Technical Memo

To: Kevin Pierard, New Mexico Environment Department, Hazardous Waste Bureau Chief
From: Diane Agnew, Environmental Manager, Albuquerque Bernalillo County Water Utility Authority
CC: Stephanie Stringer (NMED), Mark Kelly (Water Authority)
Date: 11/19/2020
Re: Analysis of Groundwater Monitoring with Passive Diffusion Samplers

Figure 2b.

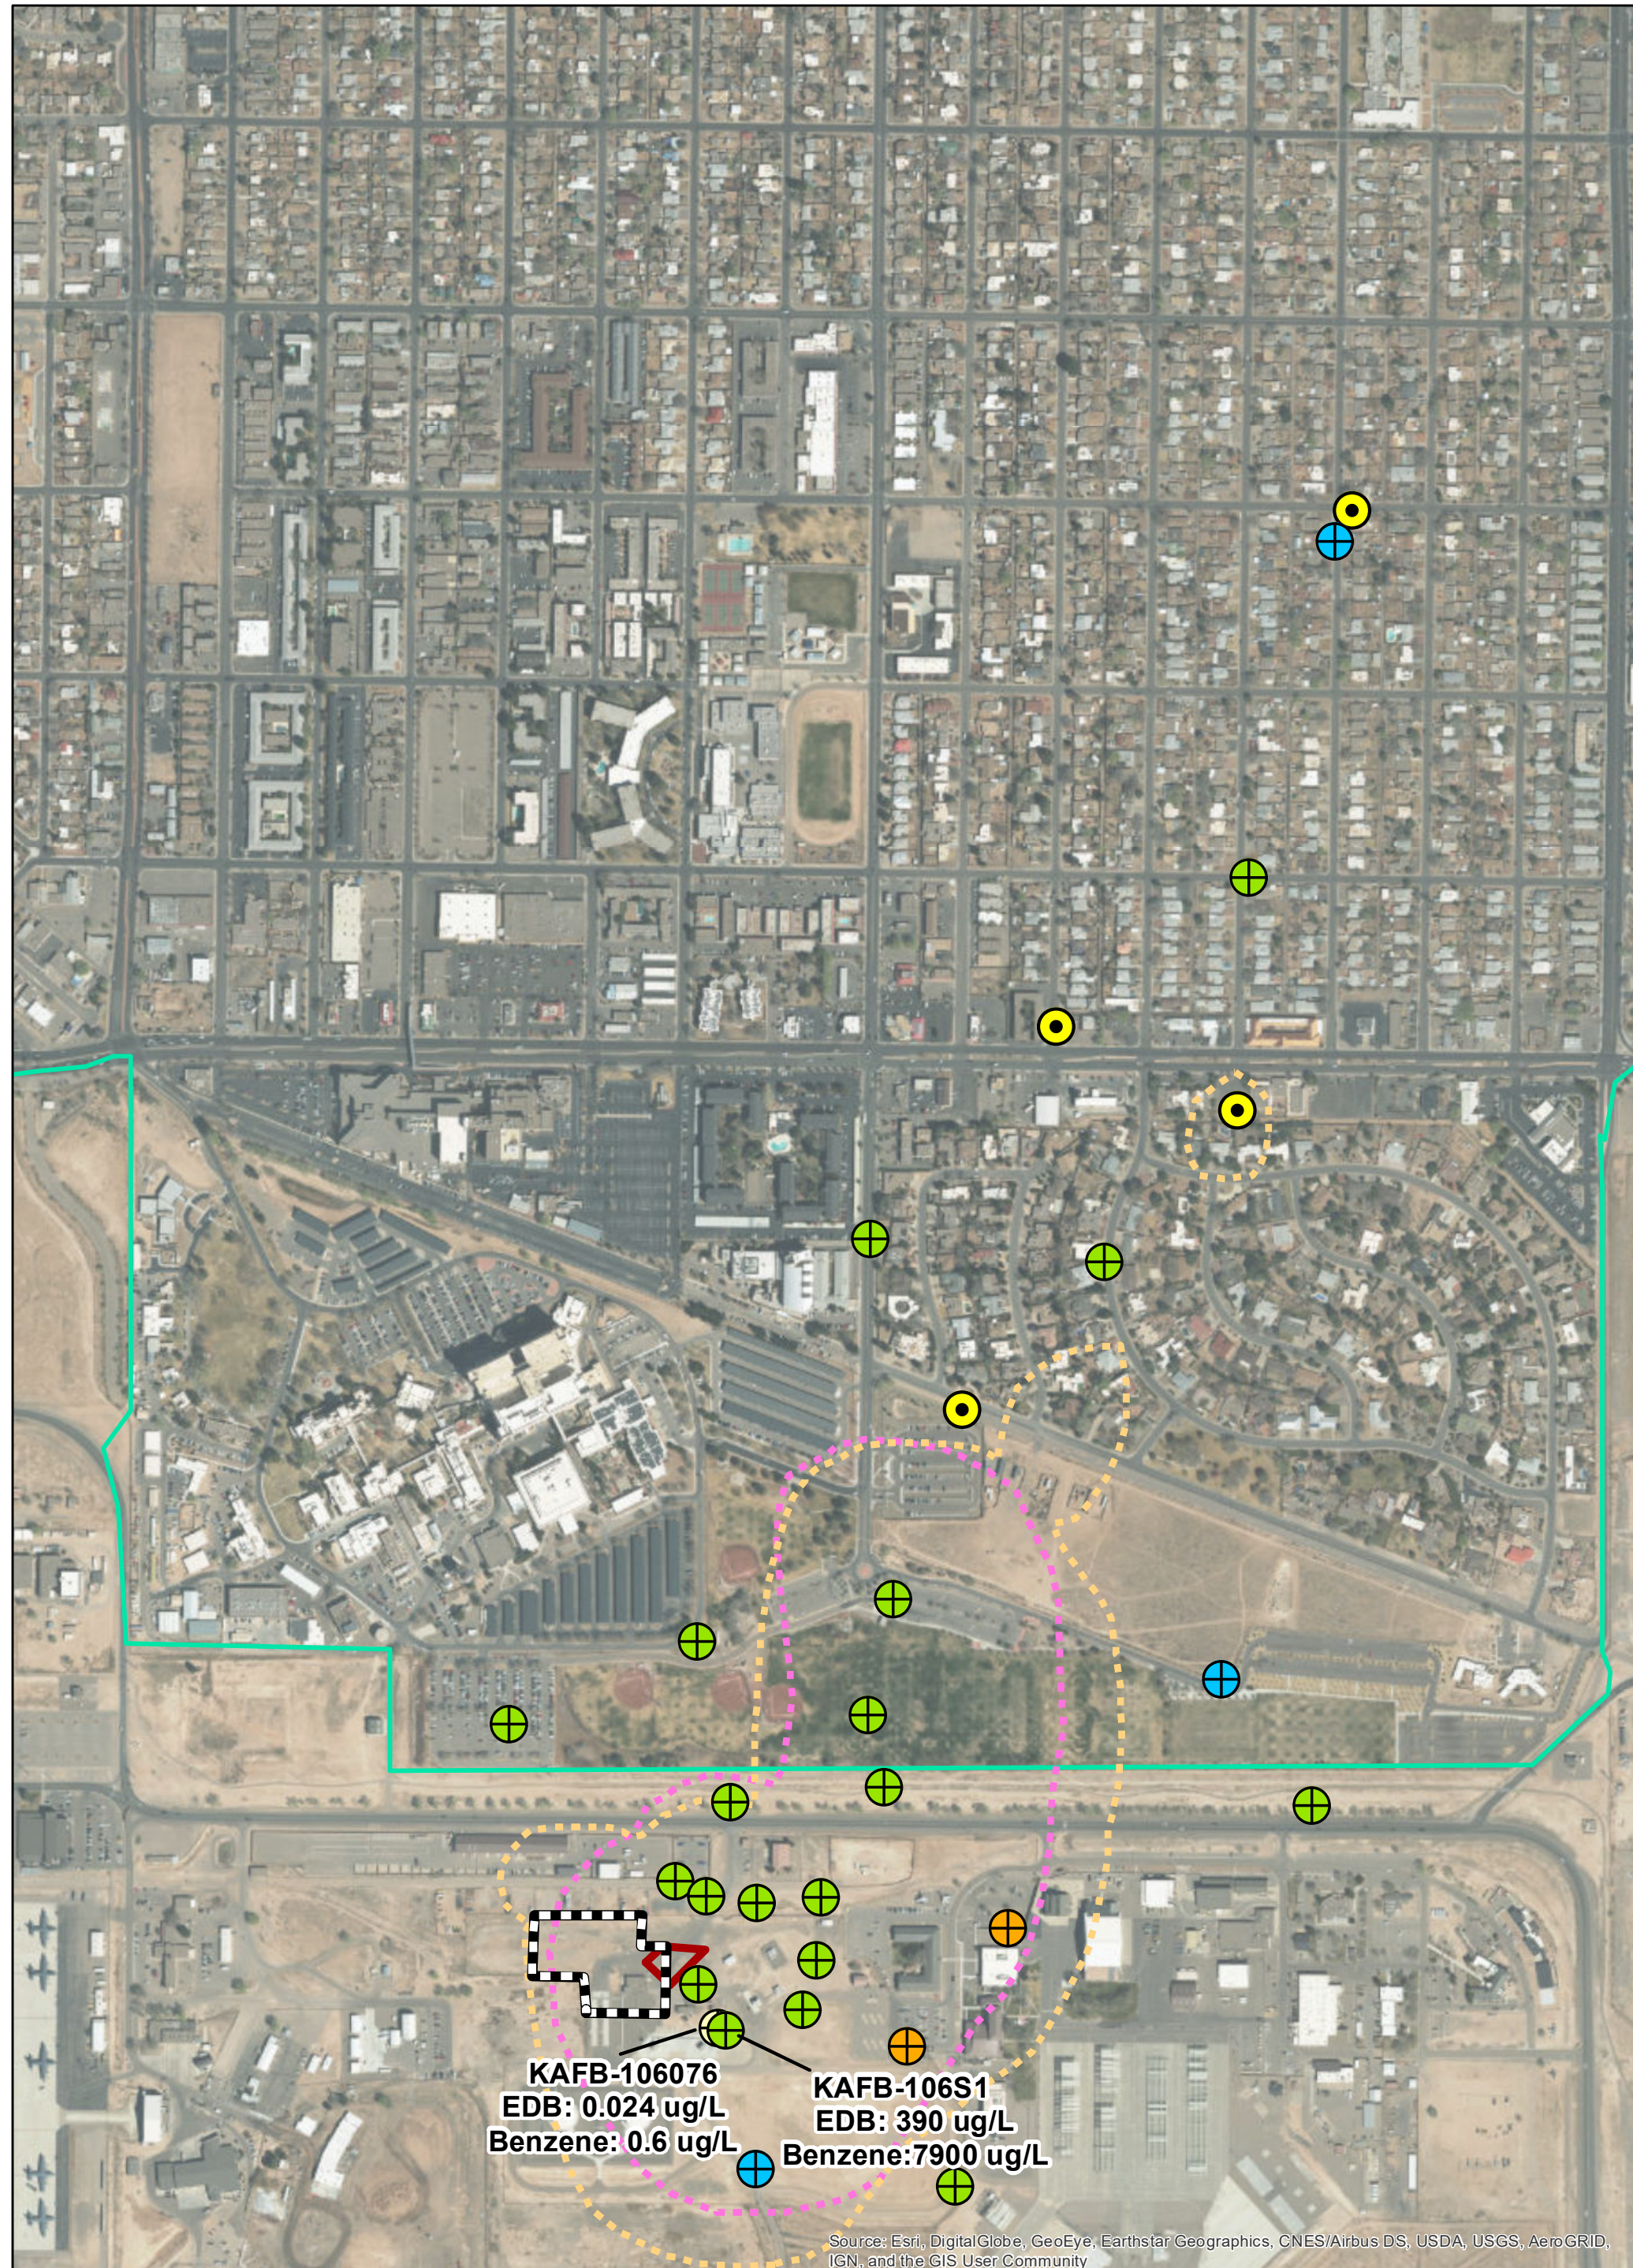
The Air Force presents its groundwater monitoring data based on three reference intervals to represent the vertical extent of groundwater contamination at the site: reference interval (REI) 4857 feet for the “water table” shallow plume, REI 4838 feet for the intermediate plume, and REI 4814 for the deep plume. Figure 2a includes the groundwater monitoring wells from Figure 3-5 from the Q2 2020 quarterly report that are reported as being representative of the water table (REI 4857), and removes wells that are submerged and no longer screened at the water table. Using groundwater elevation data from Q1 2016 through Q4 2019, the average annual water table rise is 3.3 feet (KAFB AFB 2019); Figure 2b illustrates the wells that will remain screened at the water table after applying this rate of change for two years. Table 2 summarizes the number of wells that remain non-submerged, and therefore, representative of plume concentrations at the water table.

- The continued submergence of wells screened across the water table results in a reduction of wells that can be considered representative of plume concentrations at the water table.

Figure 3

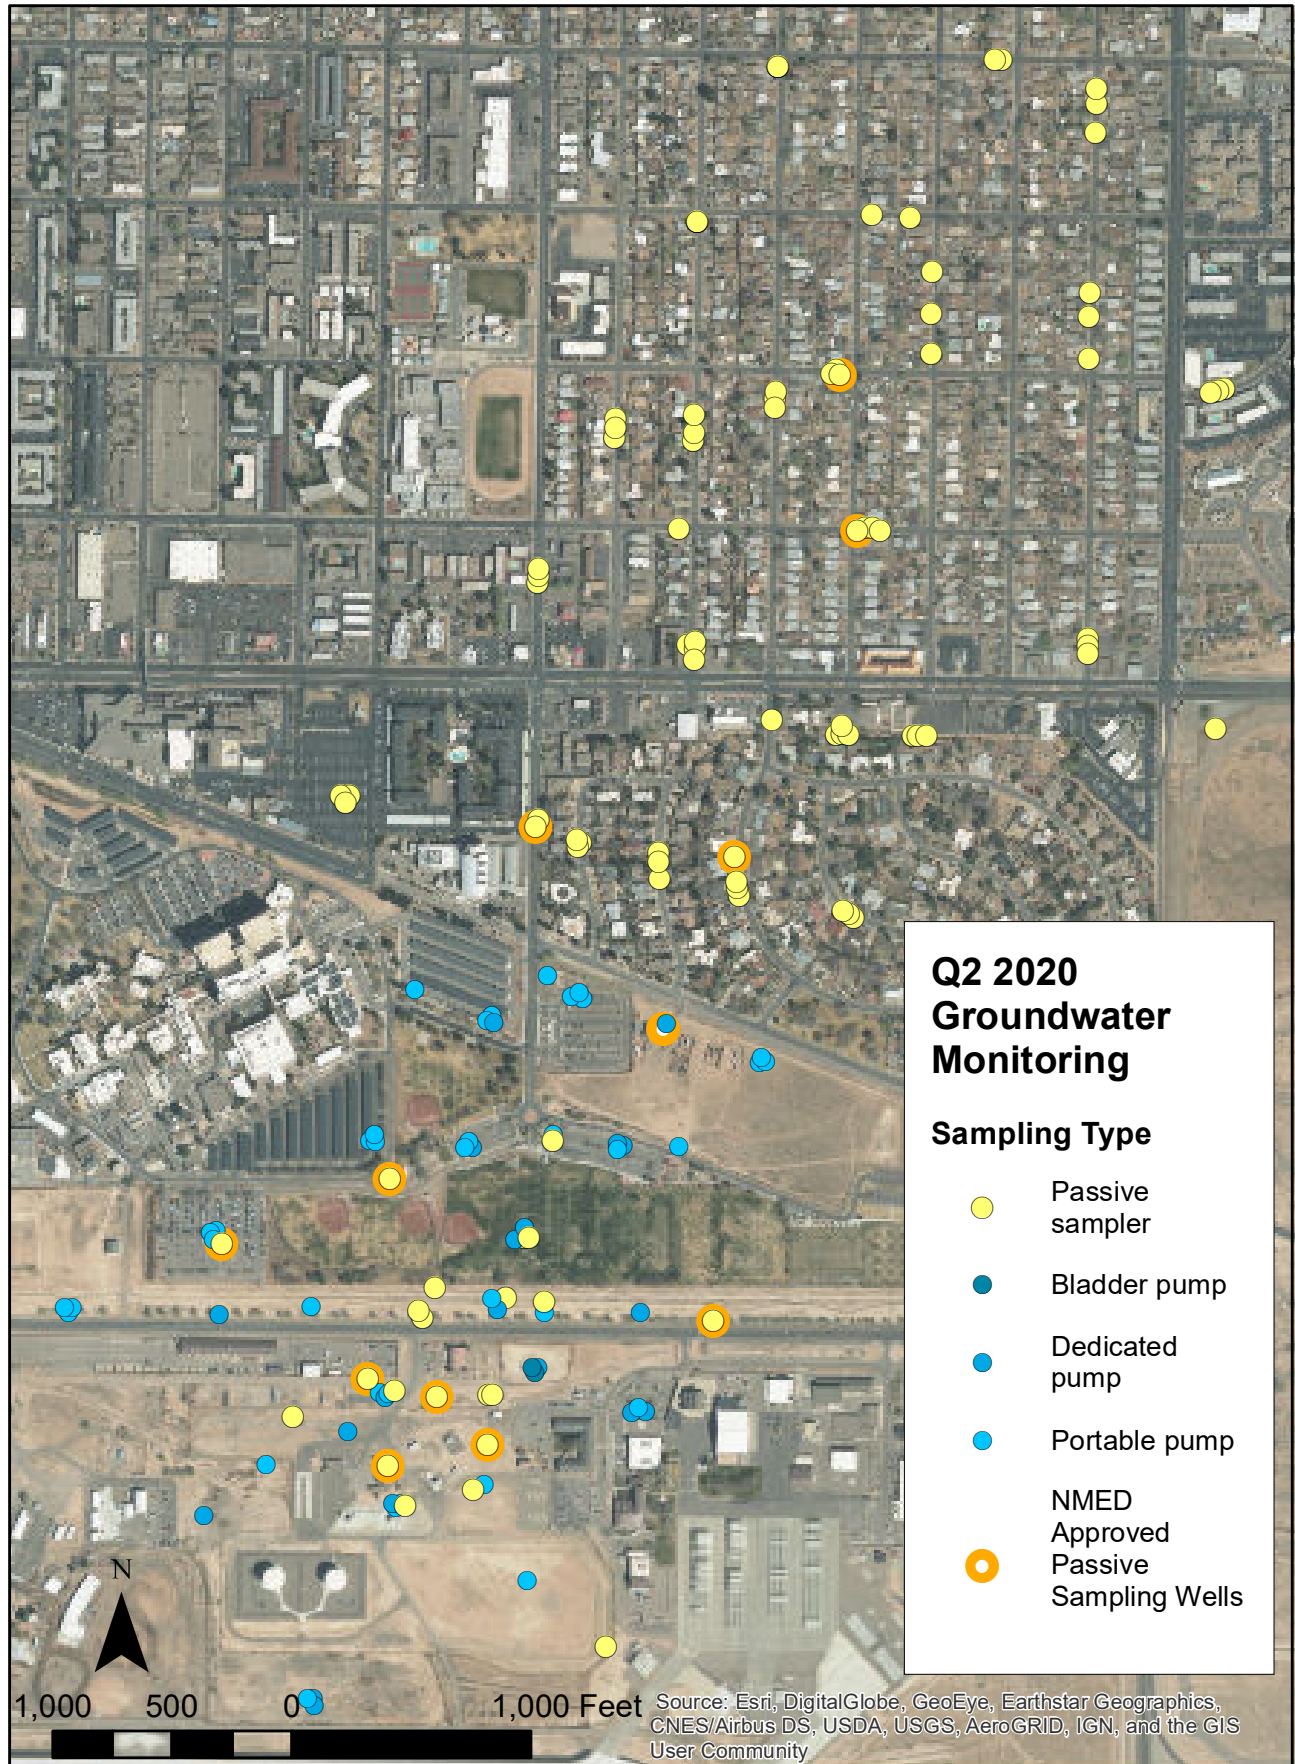
- The REIs reported by the Air Force have not been adjusted in the past four years despite a nearly eight-foot increase in groundwater levels. As a result, the REI assigned to represent the deepest portion of groundwater contamination is likely biased low, and therefore, not a definitive indicator of the depth of contamination.
